**ZONING AMENDMENT
& SUBDIVISION STAFF REPORT****Date: June 6, 2019**

| <u>APPLICANT NAME</u> | CA Properties II, LLC |
| <u>SUBDIVISION NAME</u> | CA Subdivision |
| <u>LOCATION</u> | Northwest corner of West I-65 Service Road North and Zimlich Avenue |

SITE PLAN

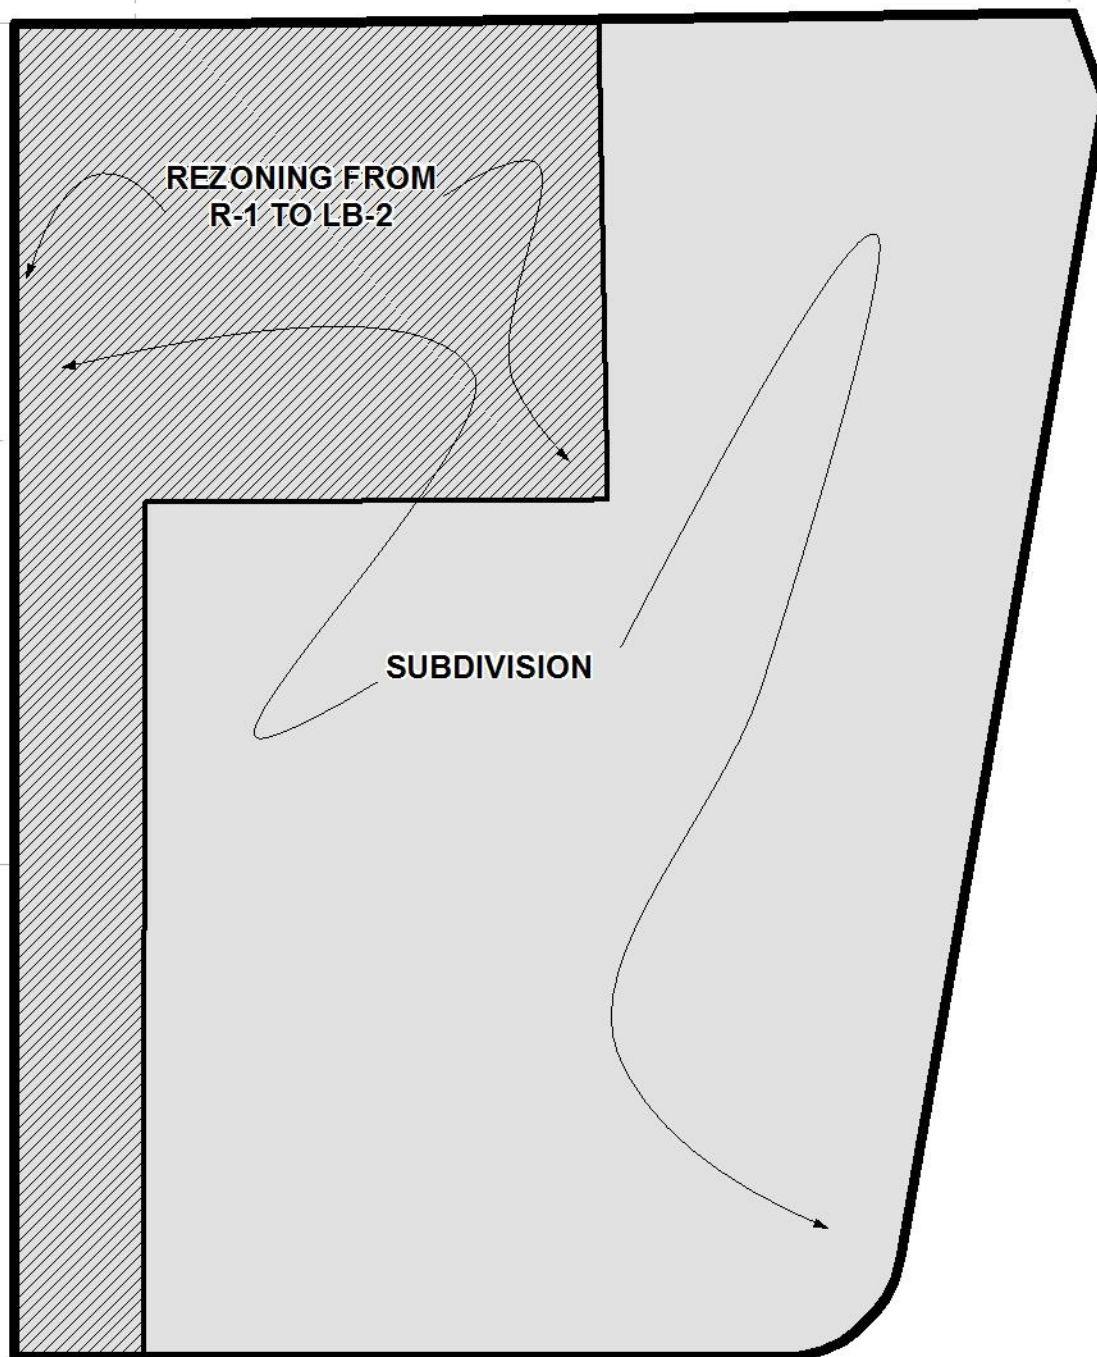
The applicant proposes to create one legal lot of record from two existing legal lots of record. The lot appears to exceed the minimum lot size requirements of Section V.D.2. of the Subdivision Regulations; however the lot size is not depicted in square feet. The plat and site plan should be revised to depict the lot size in square feet and acres or provide a chart furnishing that information.

The site has frontage along Zimlich Avenue, a minor street with a 50' right-of-way. The site also has frontage along I-65 Service Road. The right-of-way width for I-65 Service Road is not labeled on the plat or on the site plan. Sufficient dedication should be provided if, needed, and a revised plat depicting the labeling of the right-of-way width along the I-65 Service Road is required. The right-of-way of I-65 plus the East and West service roads should be 300 feet total.

The 25-foot minimum building setback is depicted along the service road, but is shown as 20' along Zimlich Avenue. The plat and site plan should be revised to be 25' along both street frontages.

Staff has reviewed the site plan submitted for the rezoning and the plan appears to comply with zoning ordinance requirements. It should be pointed out that the proposed site plan does depict two buildings on the proposed lot, thus a Planned Unit Development application will be required prior to the submission/ approval of the construction of the second building indicated on Phase 2, however, an Administration PUD may be allowed if the development will be fully compliant with Zoning Ordinance requirements.

- 1) revision of the plat to depict the lot size in square feet and acres;
- 2) revision of the plat to label the right-of-way width of the I-65 Service Road (dedication should be provided if, needed) (300 foot minimum total right-of-way required for I-65 and service roads);

- 3) retention of the labeling of the right-of-way width of Zimlich Avenue;
- 4) depiction of a 25' minimum building setback line on all street frontages;
